CITY OF SEGUIN & GUADALUPE COUNTY

30% SUBMITTAL

FEDERAL AID PROJECT
PROJECT NO.
CSJ: 0915-46-052
LIMITS FROM: SH 46
TO: SH 123

FOR WORK CONSISTING OF EXPANDING ROADWAY FROM 2 TO 4 LANES WITH RAISED MEDIAN OR CENTER TURN LANE. REALIGN CORDOVA ROAD AT SH 46. ADD SHARED USE PATHS.

PROJECT LAYOUT
 BEGIN PROJECT TO STA 159+00
 SHEET 1 OF 5

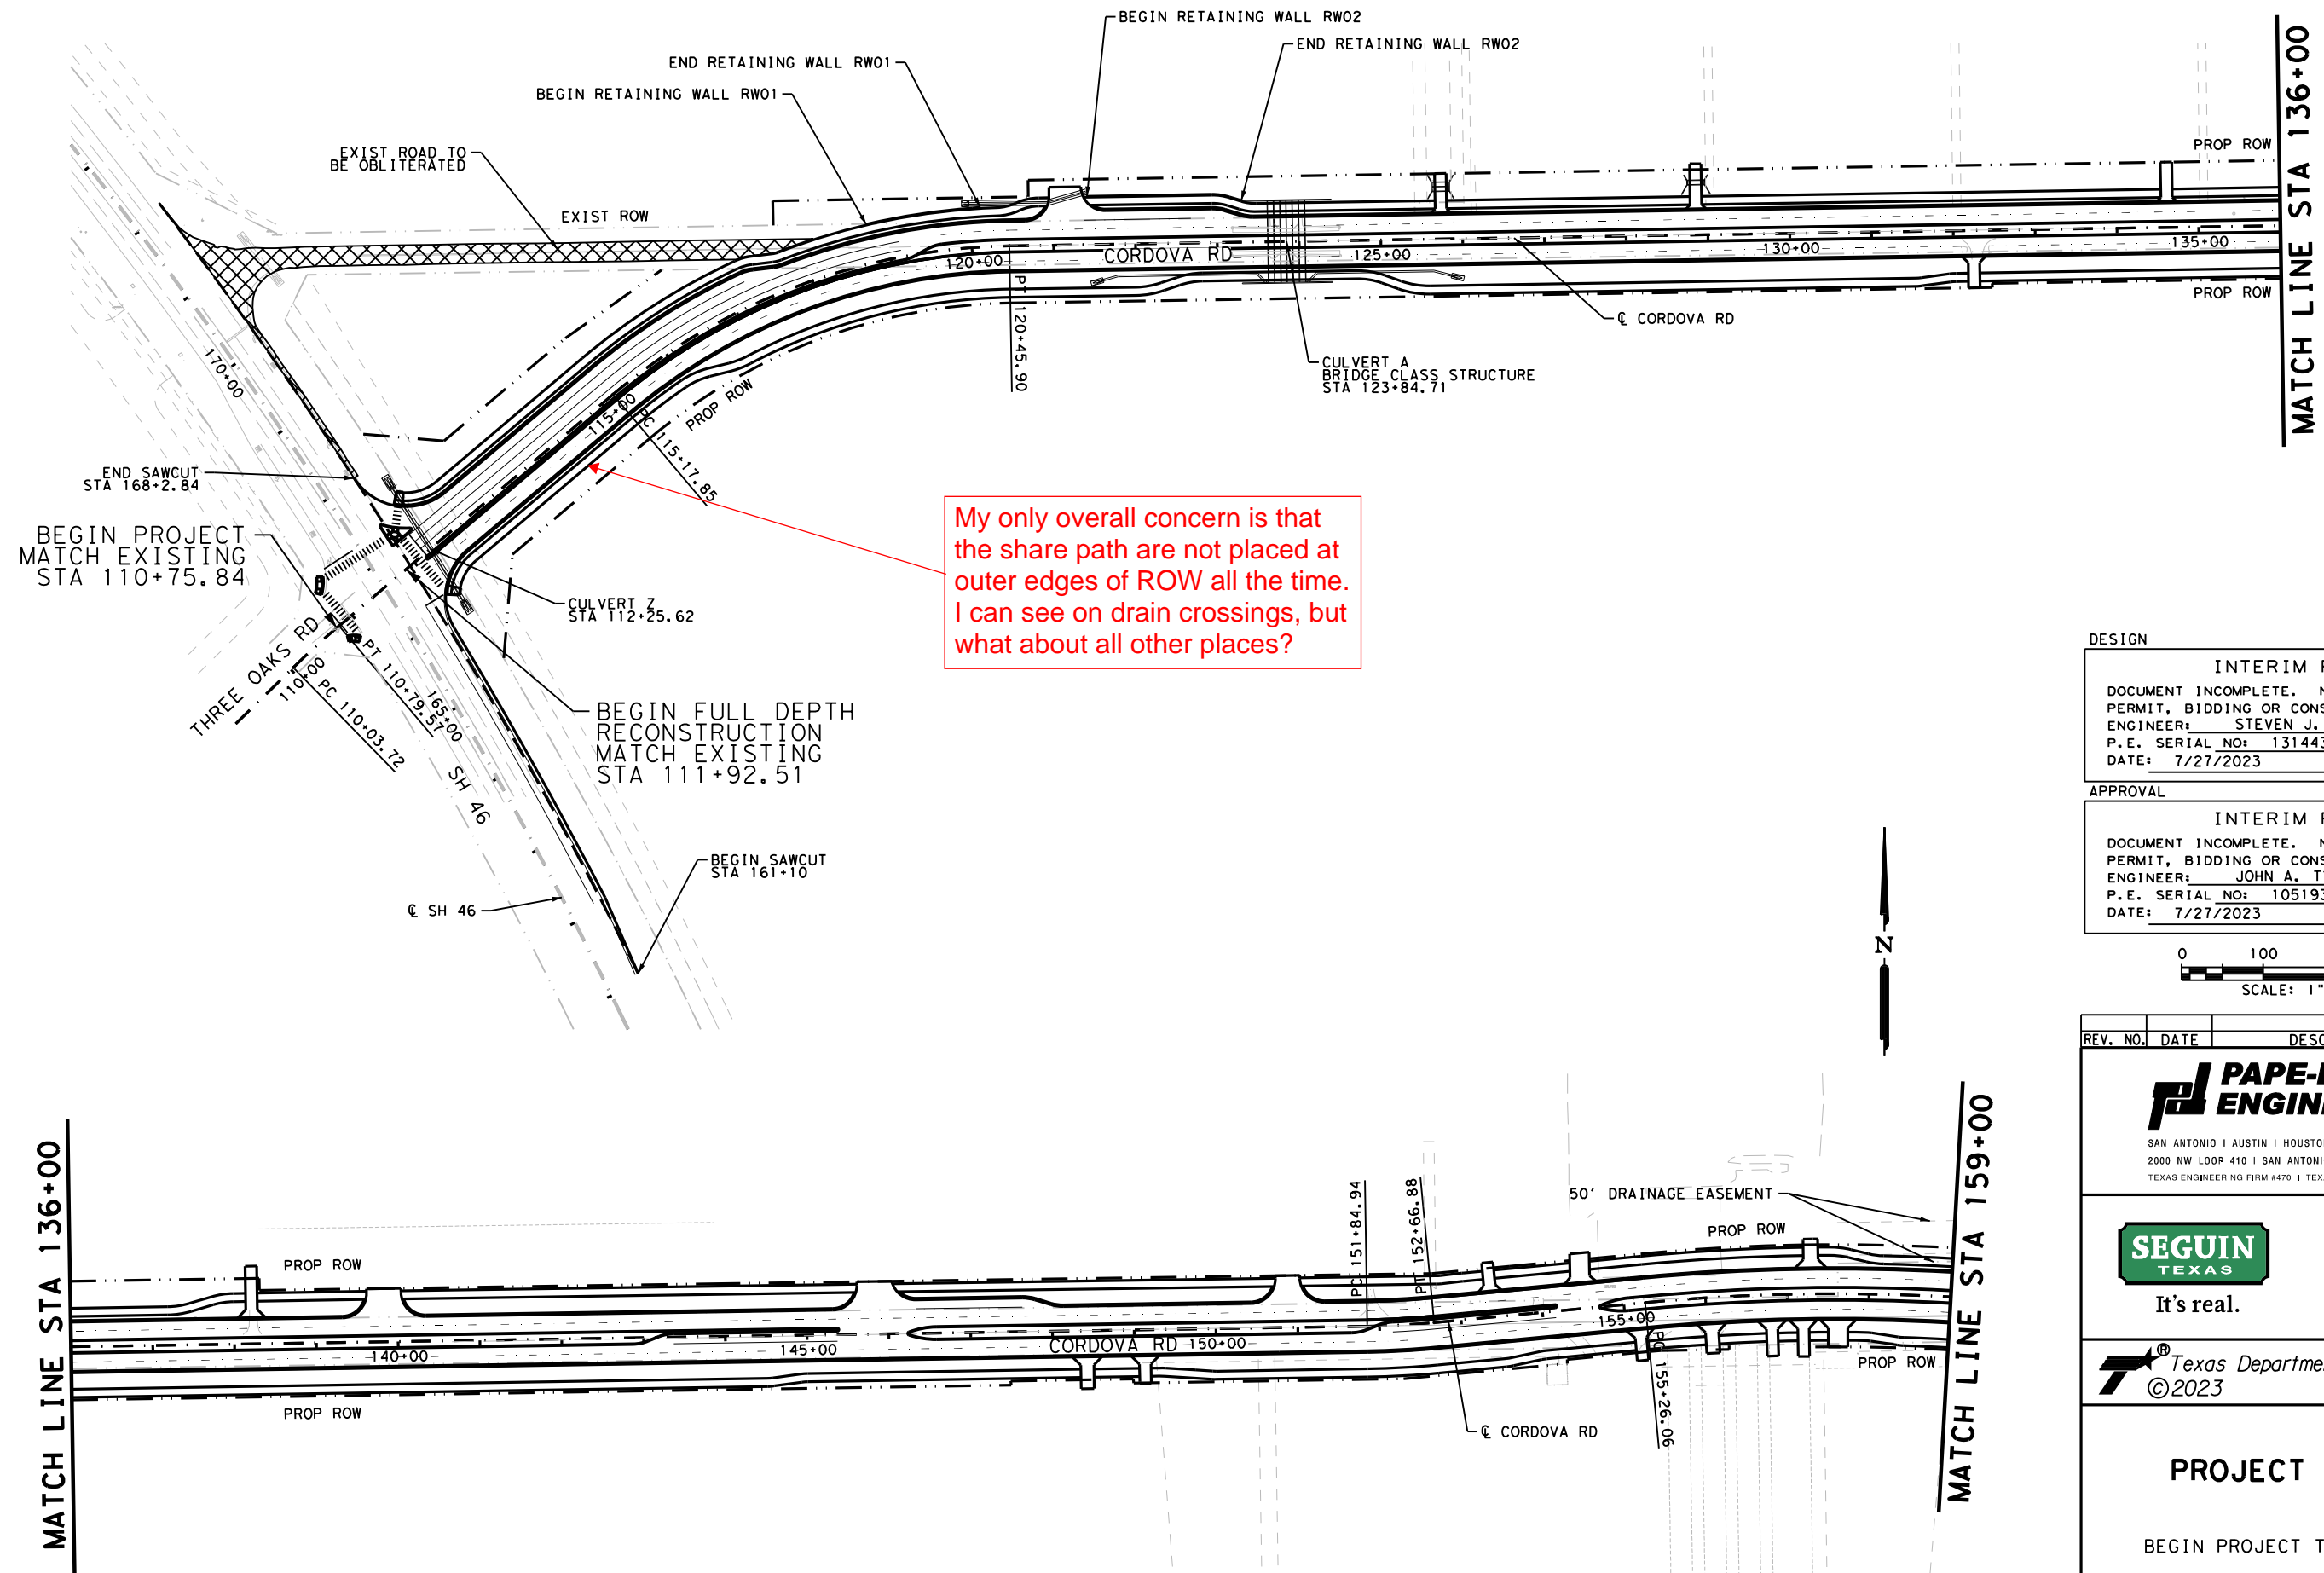
My only overall concern is that the share path are not placed at outer edges of ROW all the time. I can see on drain crossings, but what about all other places?

SHEET 2 OF 5

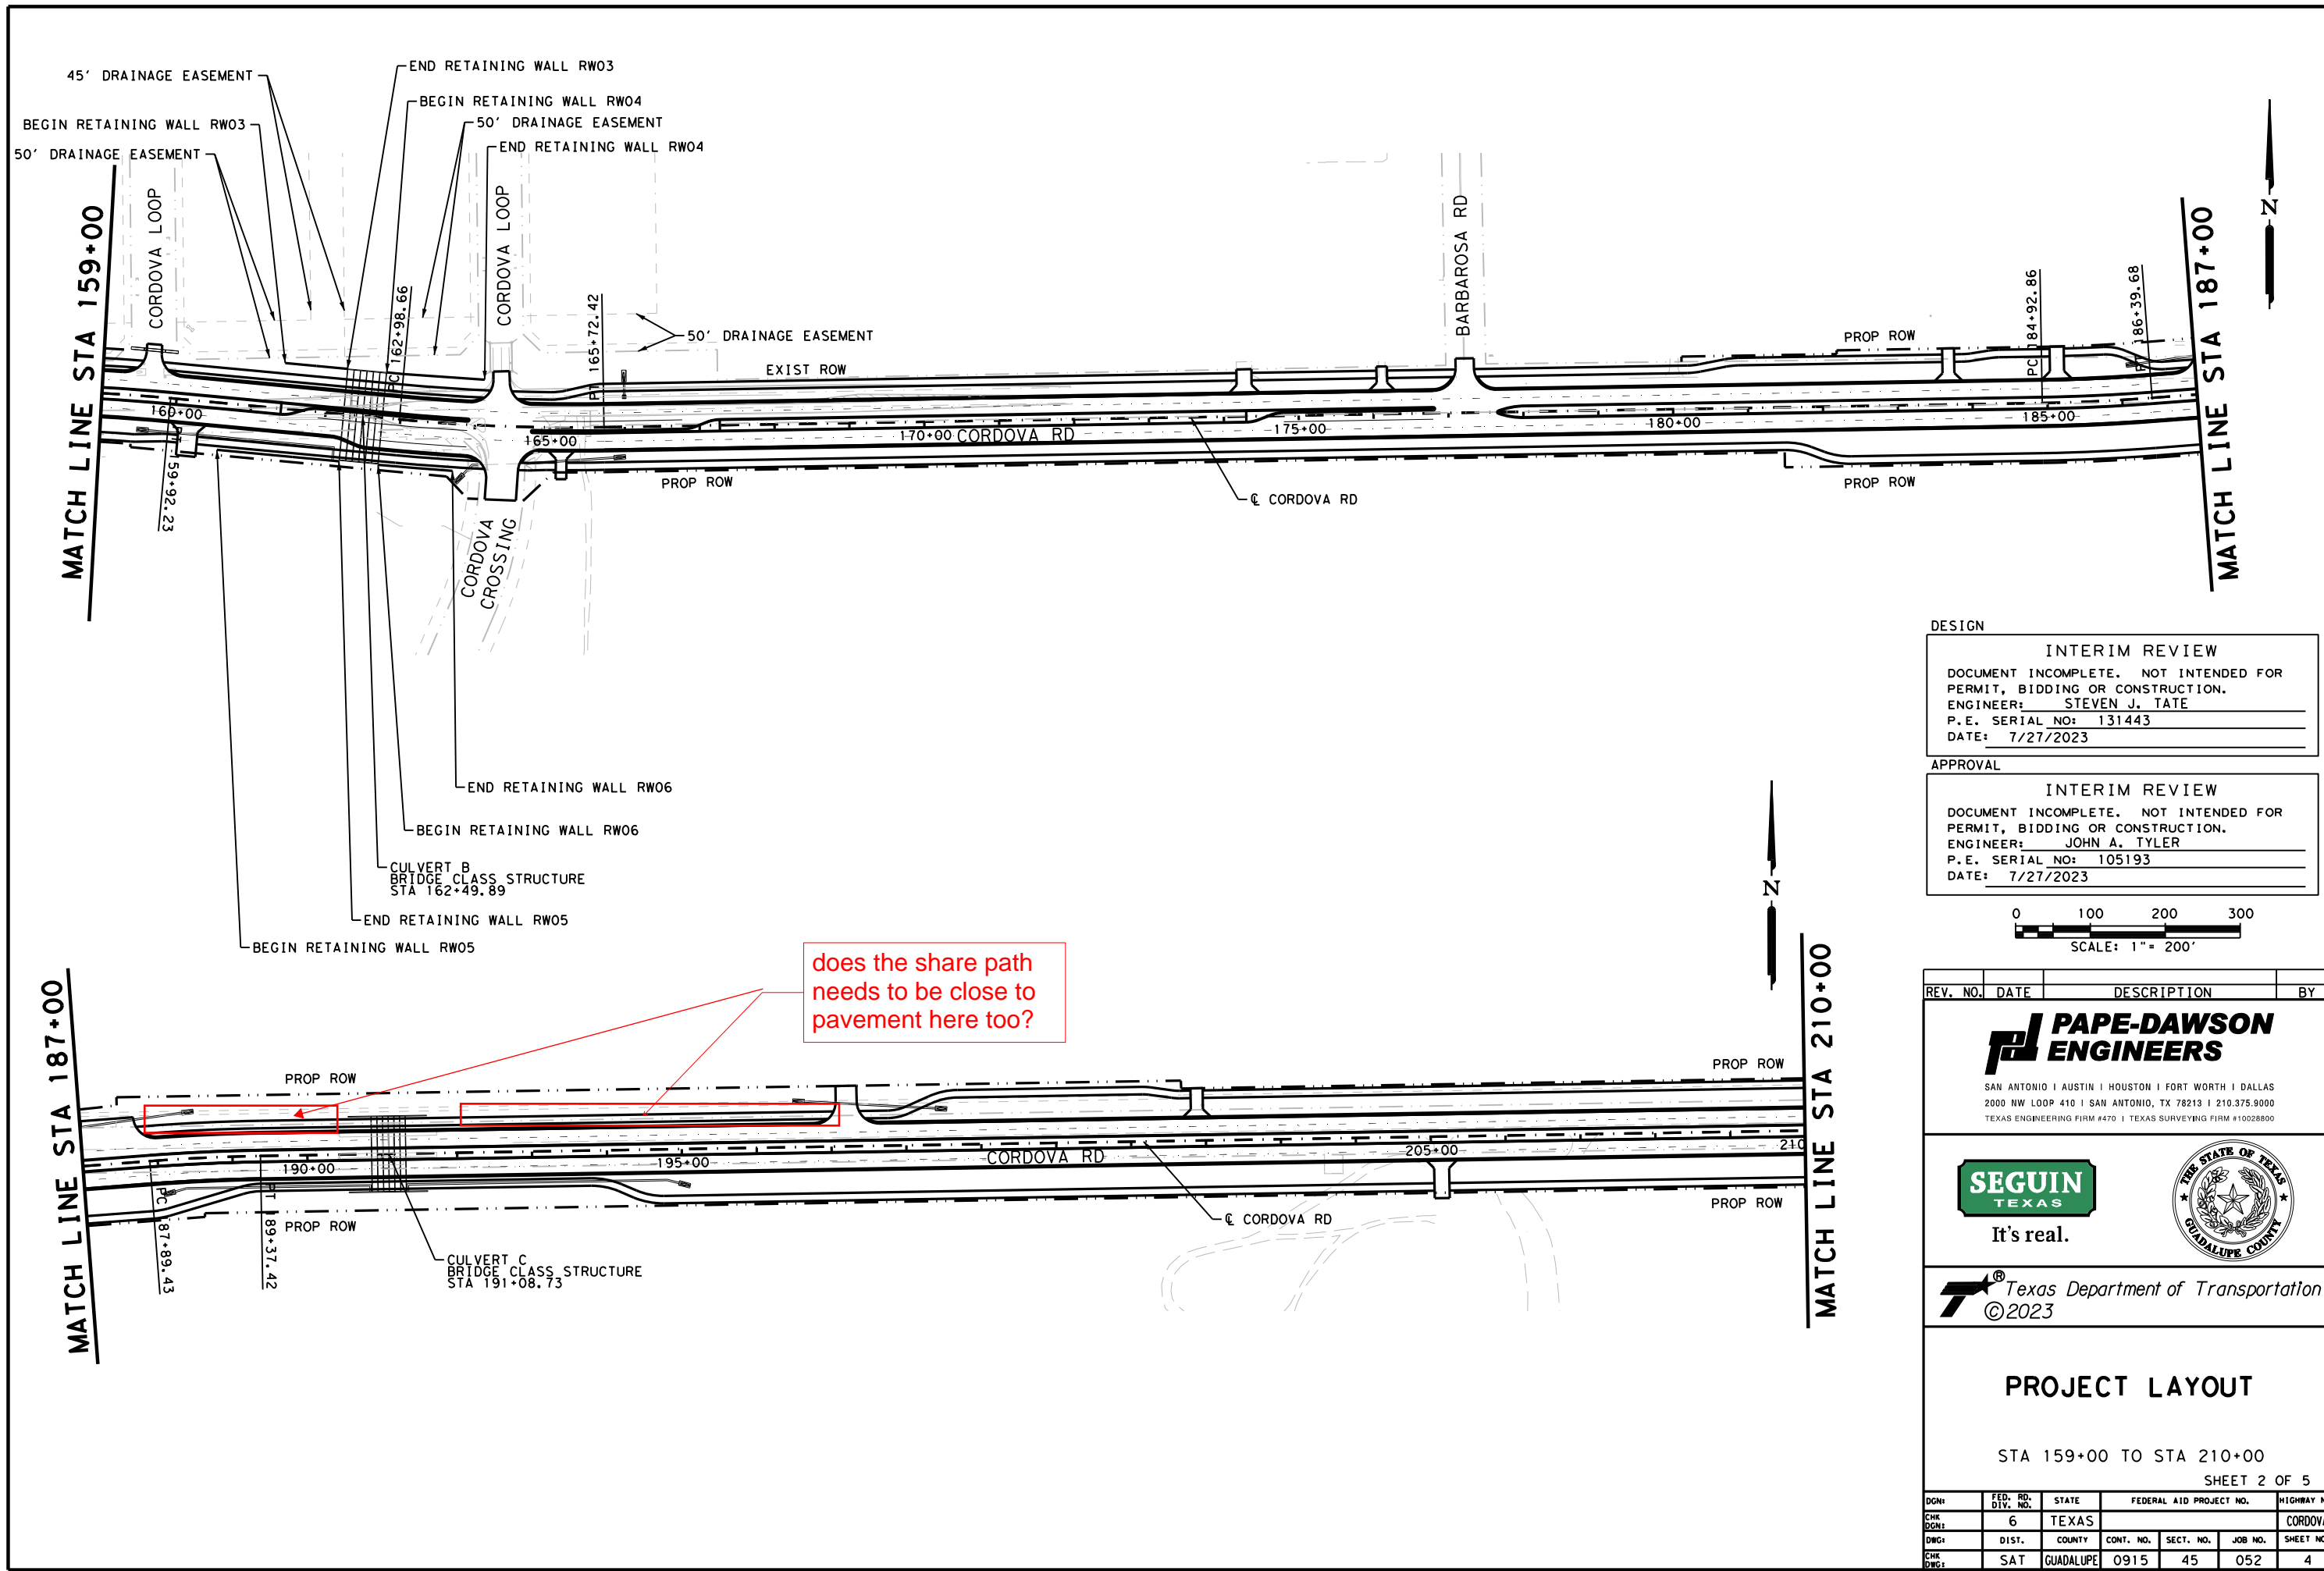
overlapping

Seguin Public Works would like to salvage all Solar powered Systems at the intersection of Huber and Cordova to reuse somewhere else. Placed note on utility plans as well.

STA 271+00 TO END OF PROJECT
SHEET 5 OF 5

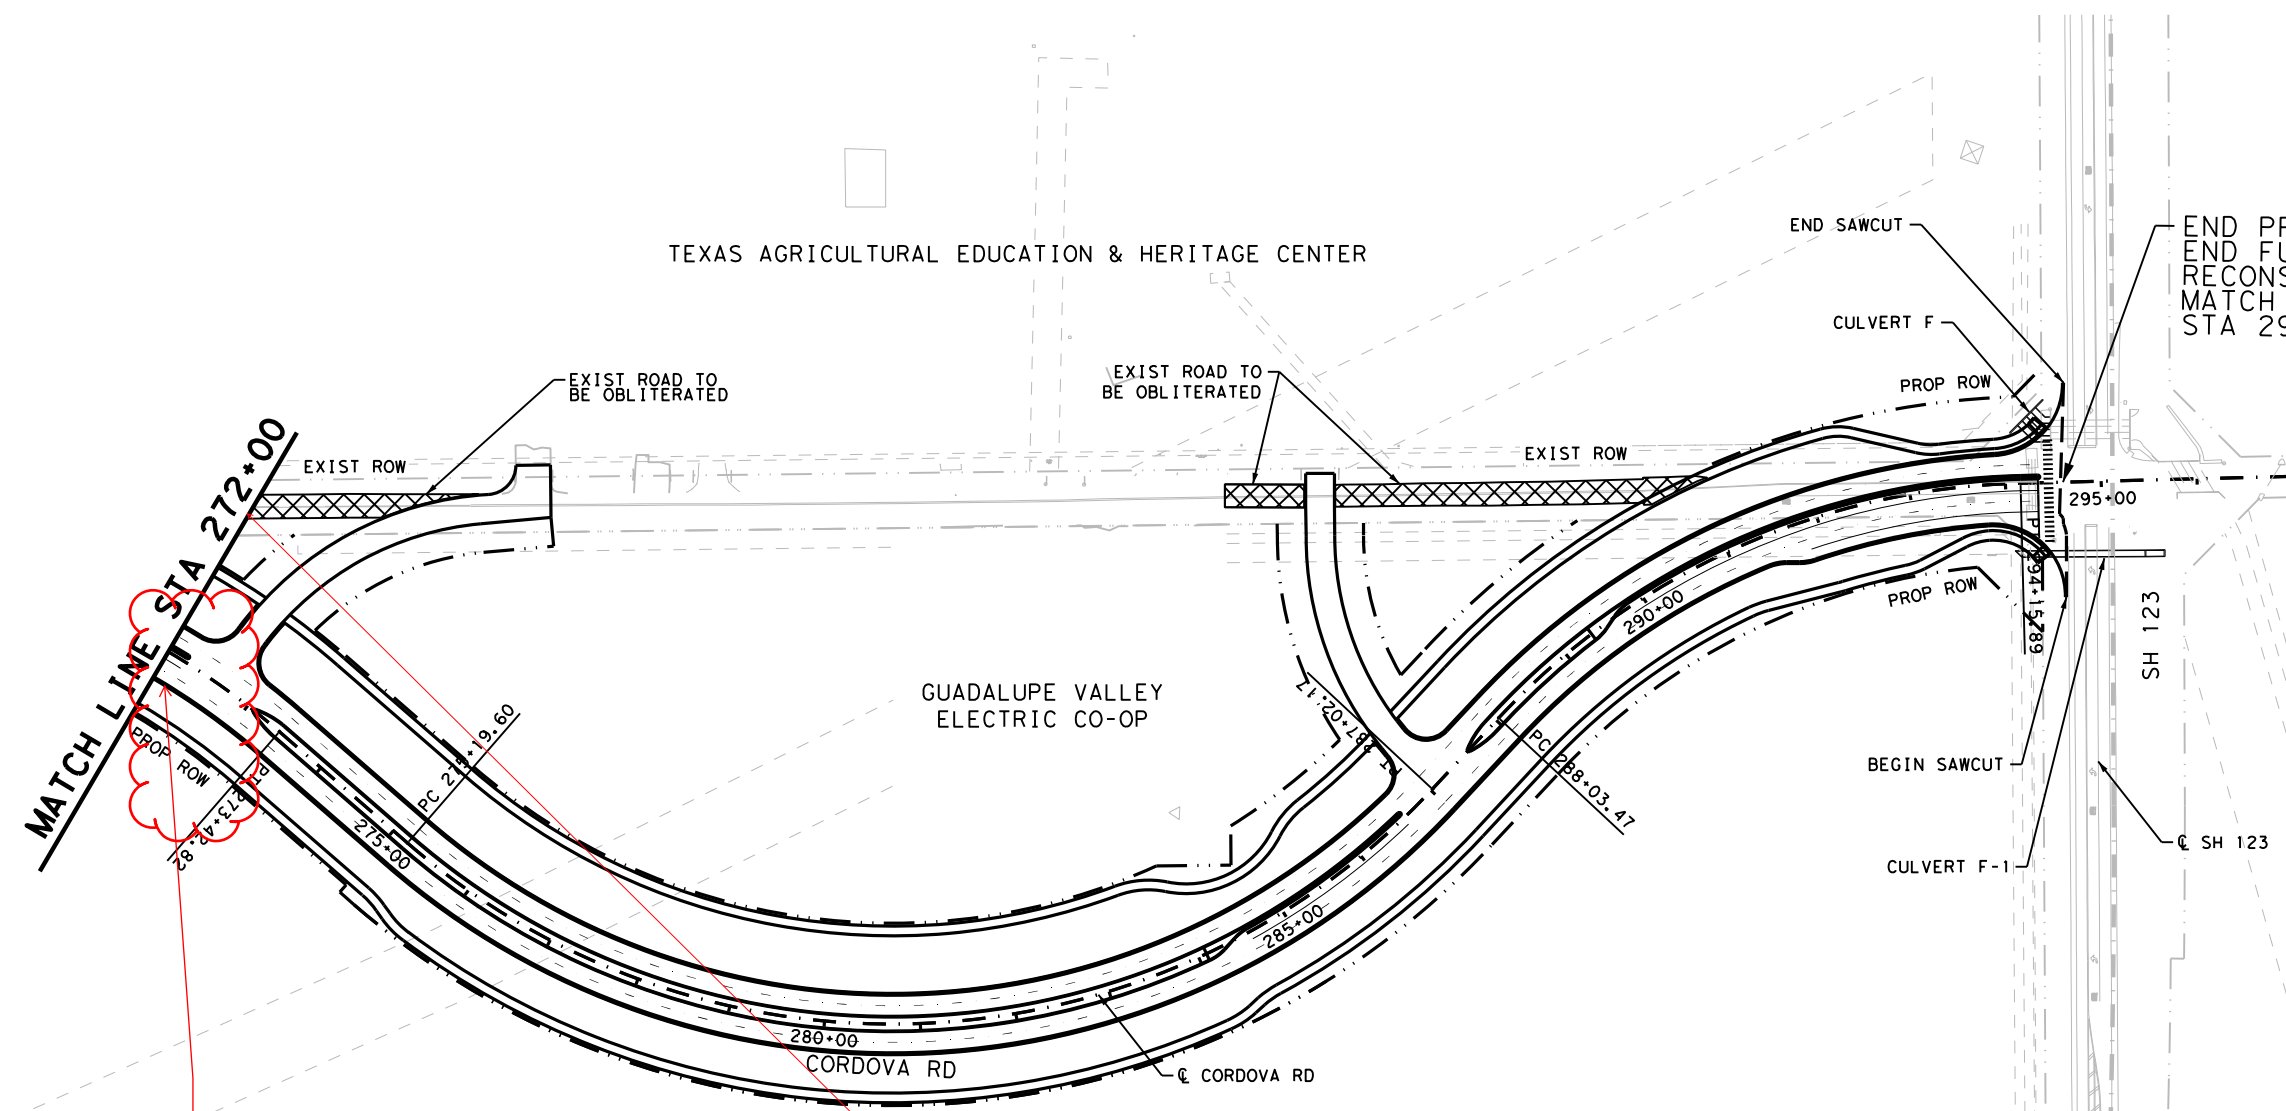
could be missing sections of road

do not match
